PLANNING AND ZONING COMMISSION AGENDA

Monday, September 10, 2018
Ketchum City Hall
480 East Avenue North, Ketchum, ID 83340

- f. **ACTION – 760 N. Washington Mixed-Use Building Pre-Application Design Review:** 760 N. Washington Ave.: (Ketchum Townsite: Block 13: Lot 6). The Commission hear public comment, consider, and provide feedback on a Pre-Application Design Review for a new three-story, mixed-use building containing commercial/retail space and one (1) community housing unit on the first-floor and one (1) residential unit on the second and third floors.

- g. **ACTION – Felker Residence Mountain Overlay Design Review:** 255 Hillside Dr. (Lot 33, Block 2, Warm Springs Subdivision #5) The Commission will consider and take action on a Mountain Overlay Design Review Application for a single-family residence in the Mountain Overlay.

ROCK RIP RAP BANK STABILIZATION DETAIL
N.T.S.

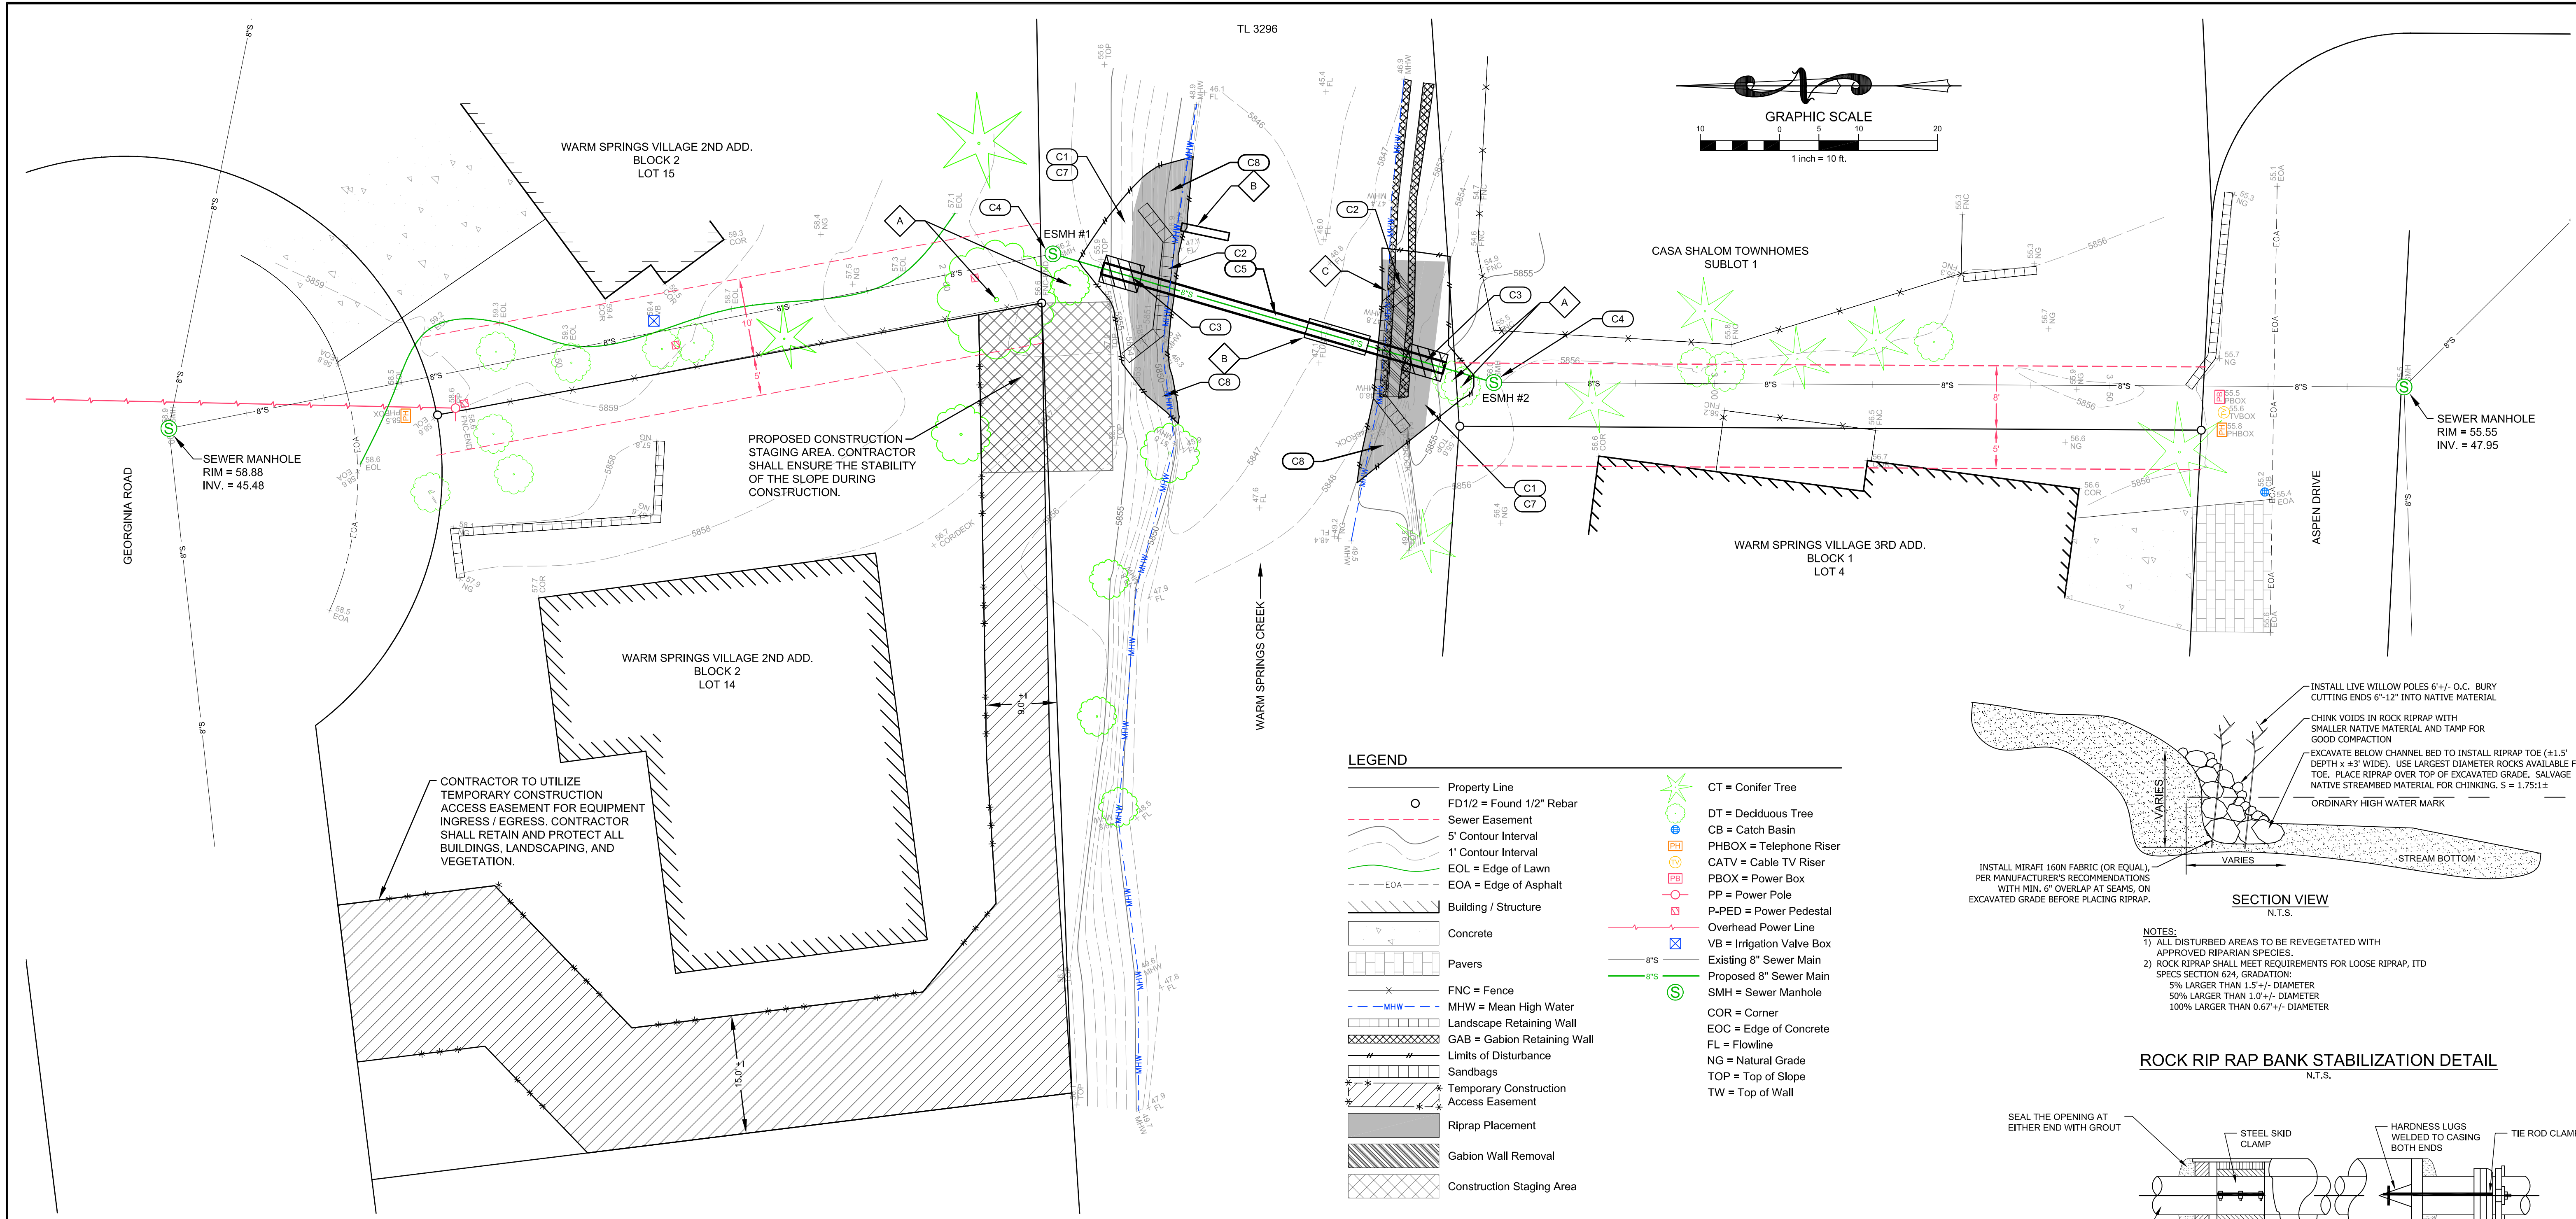
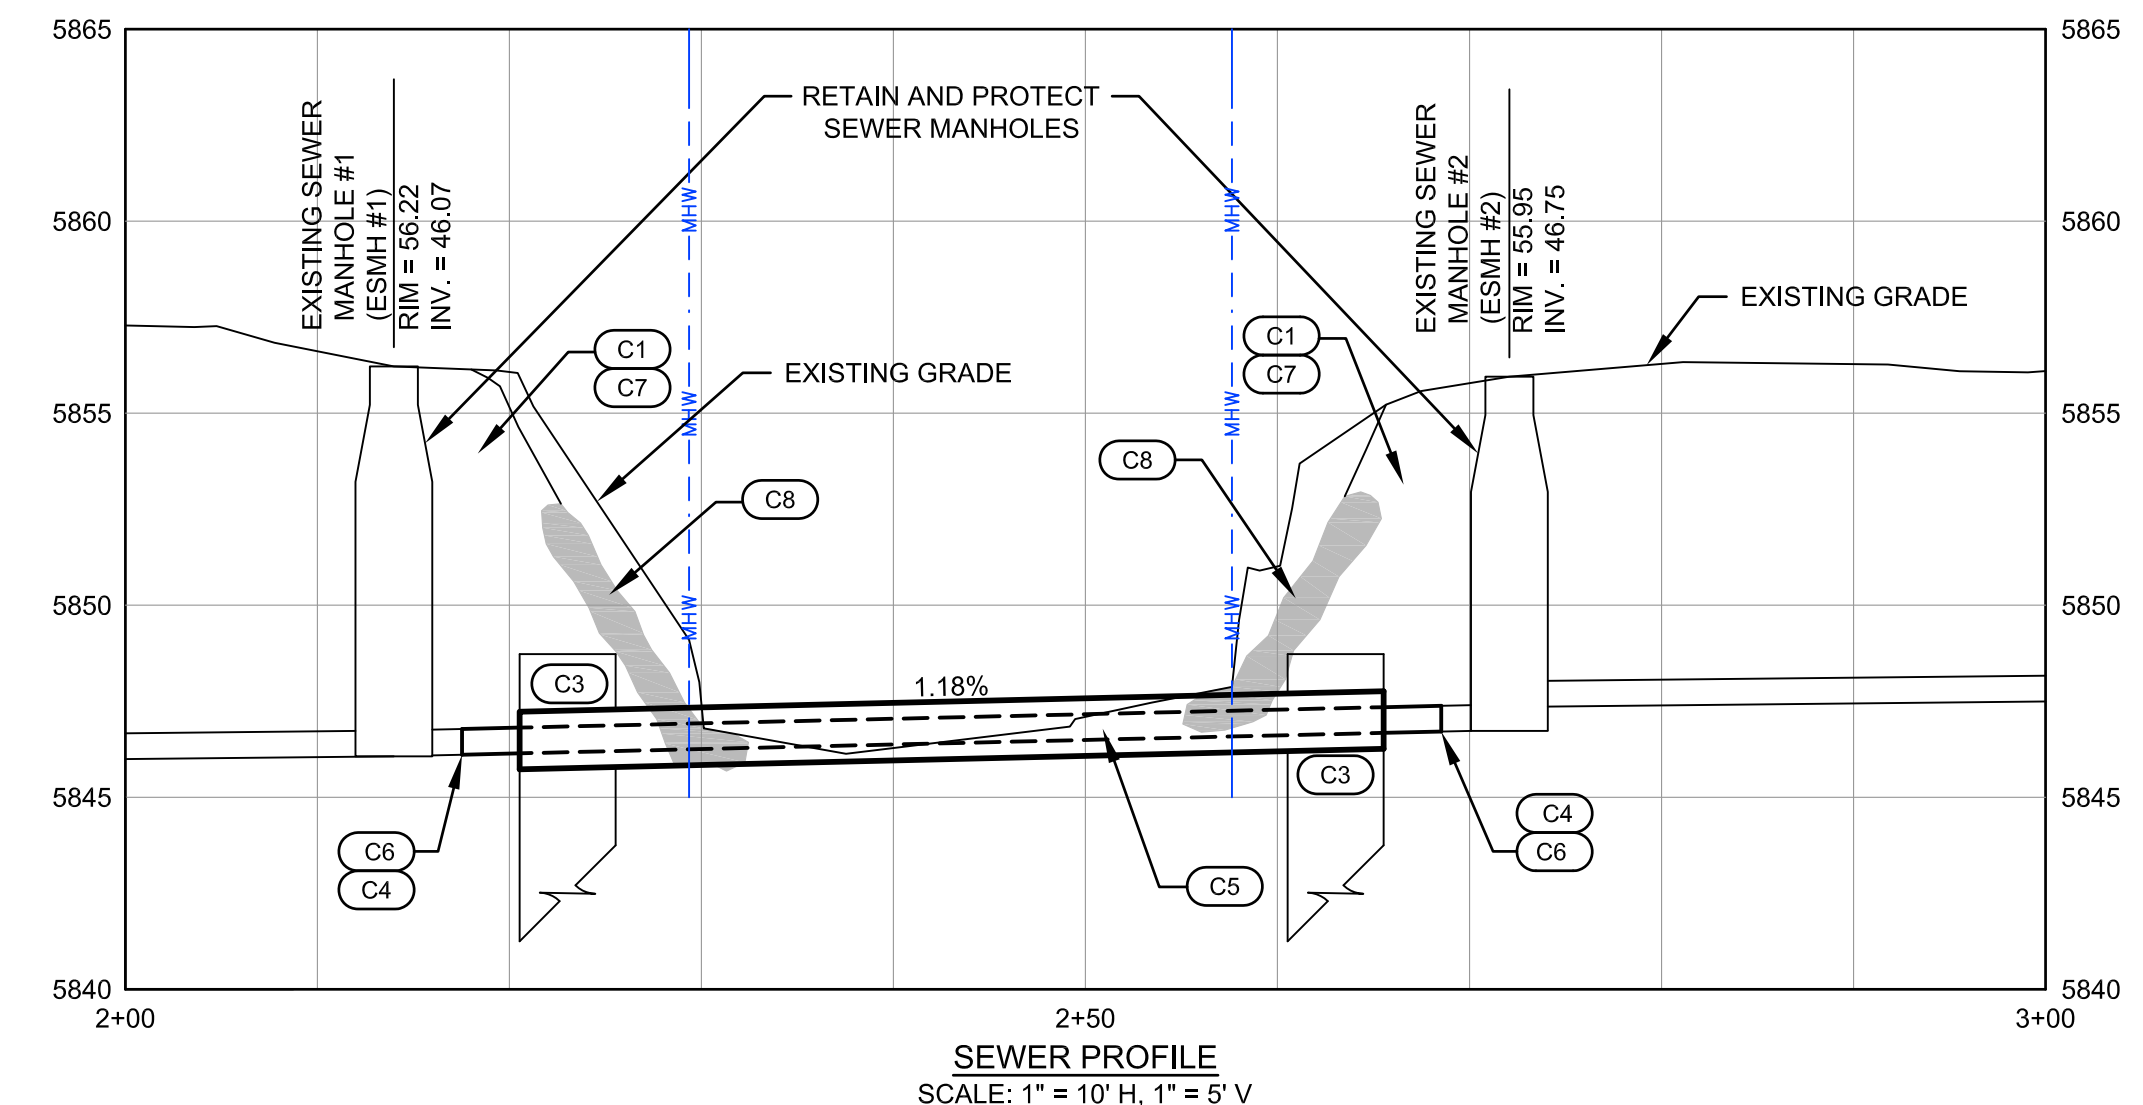
We agree with the decision not to plant vegetation on or around the scour pad as rip-rap will likely not support it. We agree as stated in the Evaluation Standards form that vegetation will be restored/repared in areas of disturbance outside of the scour pad. However, we did not find any information on what species of vegetation would be used to restore the disturbed areas.
